Reference: #16S1109000

**RE: LETTER ADDENDUM TO ADDRESS COUNCIL COMMENTS
 511 PRINCES HIGHWAY, ROCKDALE**

This letter provides a response to comments provided by Bayside Council (Council) on the Planning Proposal for the land identified as the 'Transport Interchange Precinct' located on Geeves Avenue, Rockdale.

This letter will form an addendum to the report "Interchange Precinct, Greeves Avenue, Rockdale – Transport Study" (Transport Report) - GTA dated 31 October 2017 and should be read in conjunction with the report.

Figure 1 – Proposed Layout Geeves Avenue

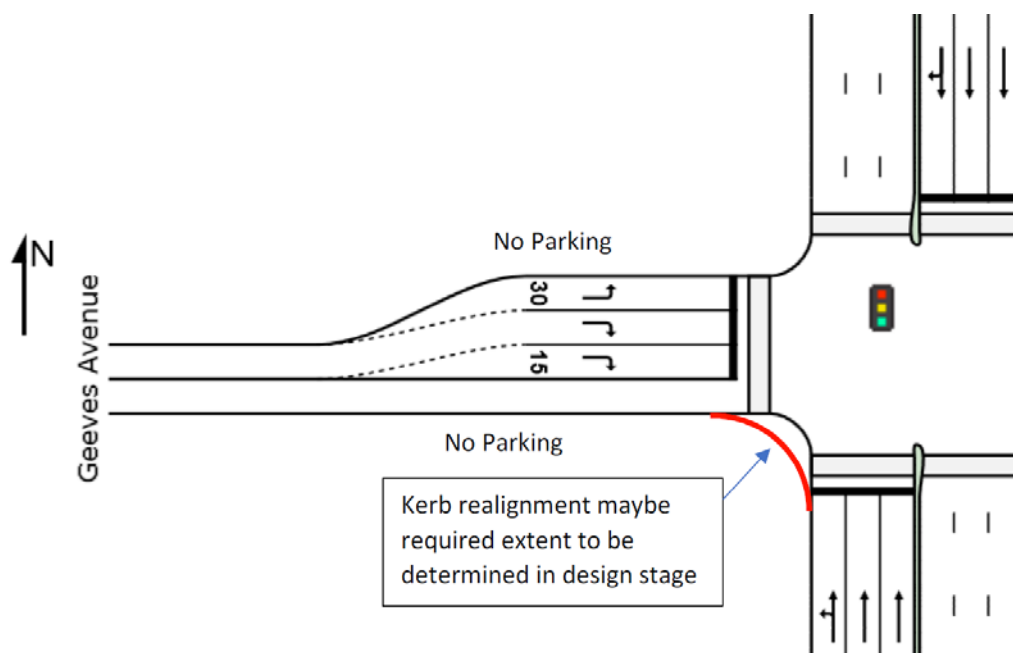
Please be more descriptive of the 'minor improvements to the lane configuration on the Geeves Avenue approach'.

The intersection of Geeves Avenue and Princes Highway has been modelled as a network with the intersection to the north and south on the Princes Highway. In isolation this intersection would operate well in the future, however the impact of surrounding intersections needs to be considered. Through removing parking on this section of Geeves Avenue additional traffic lanes can be added on the Geeves Avenue approach to allow more right turning traffic to get through the intersection in the allocated green time. This would result in the loss of around six (time restricted) parking spaces and two loading zones. The parking and loading zone on the southern side would currently be used for the existing development. These modifications would assist to increase the capacity of the right turning vehicles and therefore improve the overall intersection performance as background traffic increases in the future. This proposed intersection layout is shown in Figure 1, please note this is a SIDRA layout representation and not a concept design.
